In the Drawings:

Appended hereto are copies of the drawing sheets bearing Figures 6 and 8 with proposed changes to those figures. Approval is requested.

## Remarks

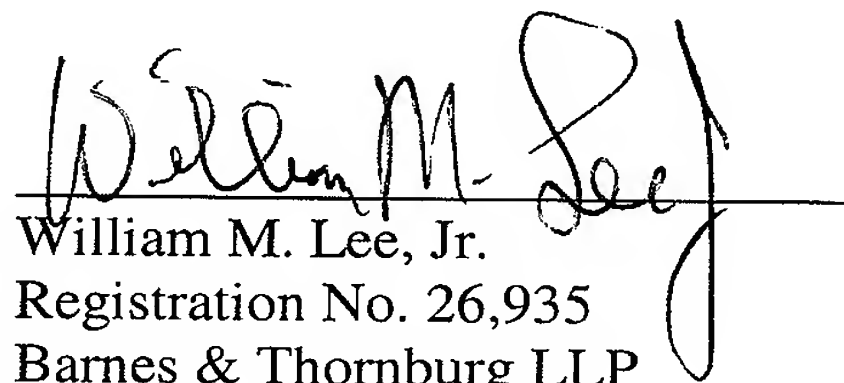
1. brace: reference number "92" is added in figure 6, and corresponding amendments are made on page 14: line 29, line 30, line 34: with (92) entered; page 16 line 5: with (92) entered.

3. triple spindle and (worm) wheel transfer: triple spindle is given reference number 90. It indicated to the right hand cylinder of unit 8. The worm wheel transfer is given reference 91 and actually is inside the part 90. Figure 8 has been amended, and the following changes are made in the specification:
